Meeting name	Imbalance Settlement Group
Date of meeting	28 July 2009
Paper title	Change Proposal Progression
Purpose of paper	For Decision
Synopsis	This paper provides: <ul style="list-style-type: none">• 4 Change Proposals (CPs) for decision; and• details of the status of all Open Draft Change Proposals (DCPs) and Change Proposals (CPs)

2.1 CP1288 – Revisions to Meter test points within Code of Practice 4

Appendix 1 – Detailed Analysis of CP1288 – Revisions to Meter test points within Code of Practice 4

Figure 1: Example showing Type A Calibration Points for a CoP1 and 2 Reactive Energy Meter

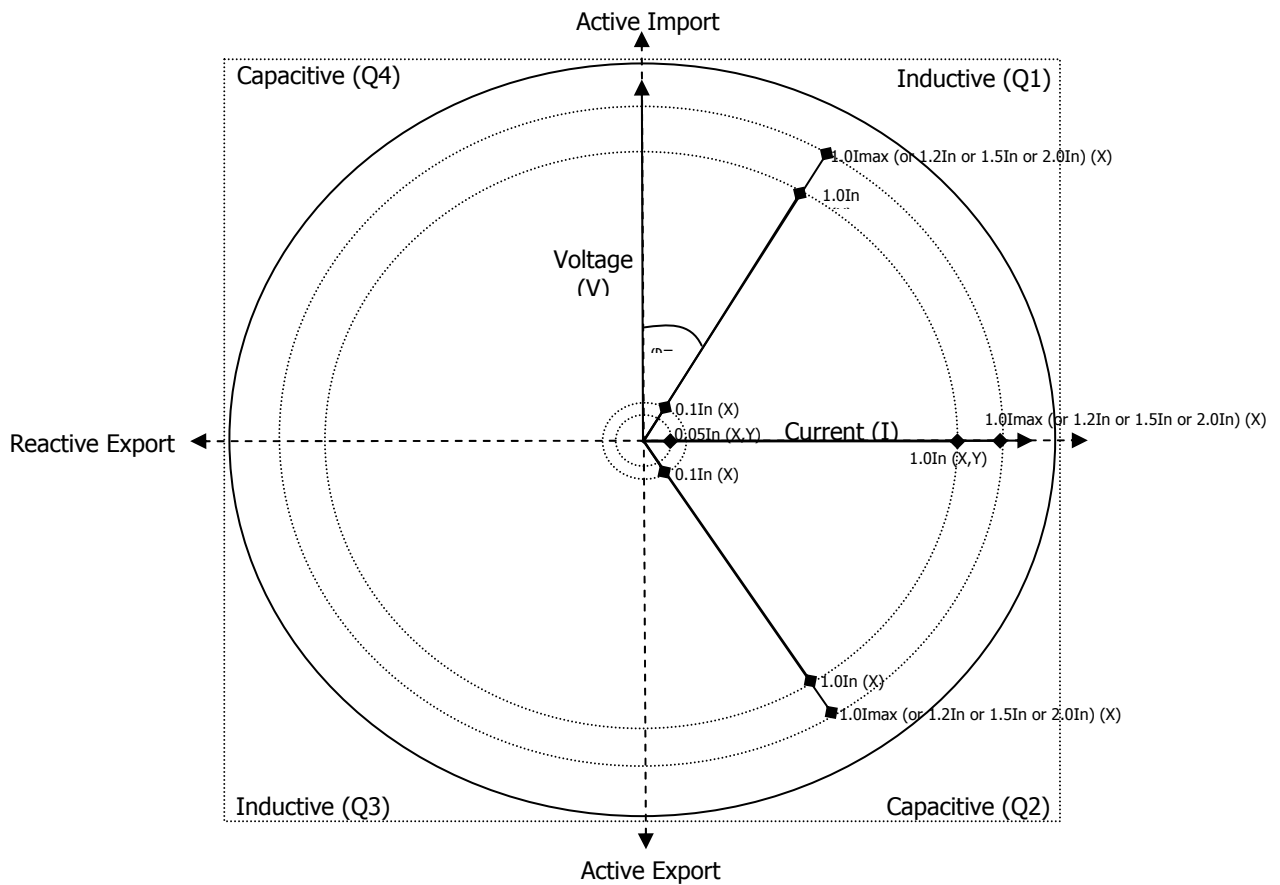
Inserting of a new diagram (Figure 1) into Appendix B to clarify the test point requirements for CoP 1 and 2 Reactive Meters

- 4.4 Additionally, a respondent suggested that the vector diagram in the British Standard 'BS EN 62053-23' is used within CoP4. We recommend that the SVG agree that the vector diagram contained in Appendix C of BS EN 6253-23 should replace the vector diagram that was issued during the impact assessment of CP1288.

Organisation	Agree?	Comments	Impact?	ELEXON Response
Cewe Instrument AB		<p>Comments: The main comment is that the vector diagram is not consistent with most international metering standards (EN62053-23 etc). To assist in understanding and reduce miss-interpretation it is preferable to use a consistent standard so all manufacturers, generators and energy suppliers use the same vector diagram.</p> <p>It would also be helpful if angular displacement from active power unity is given (e.g. 0 = unity pf active power, +60 0.5 inductive power factor (active energy), -60 0.5 capacitive power factor (active energy), 90 = reactive import etc.</p> <p>Is it also realistic to have single phase load points on 3ph 3wire systems?</p> <p>Capacity in which Organisation is impacted: We are a supplier and would like to be completely clear as to the exact measurement points required for the type A calibration for CoP1 and CoP2 meters.</p> <p>Impact on Organisation: Test systems need to be reprogrammed to accommodate any changes from existing interpretation.</p> <p>Implementation: 30</p> <p>Comments: Time to change our calibration systems which are now tailored to UK CoP4 requirements.</p> <p>Would implementation in the proposed Release have an adverse impact? We would have to submit our interpretation and seek approval from Elexon, for Type A calibration points.</p> <p>Costs: Minimal costs are envisaged (1 man day), the important thing is to have a consistent vector diagram so we only need to do the job once.</p>	Yes	<p>ELEXON agrees and recommends that the vector diagram contained in the British Standards should be used in place of the proposed vector diagram issued for impact assessment with CP1288. This diagram can be found in Appendix C of BS EN 6253-23.</p> <p>ELEXON contacted the respondent to clarify that single phase load points are required for 3ph 3wire networks.</p> <p>Impact of implementing the solution is noted. The respondent noted that they would prefer to confirm the new meter test point requirements with ELEXON. 30 days as a minimum is required to change their internal systems.</p>

No	Organisation	Document name	Location	Severity Code ⁵	Comments	ELEXON Recommendation
1	Cewe Instrument AB	CoP4	App 1 table B1 vector diagram	H	Internationally recognised standard diagram to be used.	As detailed in our response to Cewe in the table above, ELEXON recommends that the vector diagram from BS EN 6253-23 is used in place of the diagram issued for impact assessment.
2	Cewe Instrument AB	CoP4	App 1 Table B1	M	Are single phase load points required for 3ph 3wire networks?	Please see our response to Cewe in the table above. We also confirmed with the respondent that no changes will be required to the redline text.
3	British Energy	CoP4	Tables B1, B2, B3, B4, B5	M	For consistency with proposed changes to the headings for Reactive Meters and Active meters on Table C1(a), and with existing headings on Tables C1 & C2, it is suggested the headings for Active meters be amended to include reference to "(Cos Ø)"	Comment noted. ELEXON recommend that the SVG agree that amendment is made, as it adds further clarity to the proposed redline text. Therefore all remaining references to 'System power factor' in tables B1 to B5 should be replaced with Cos Ø.
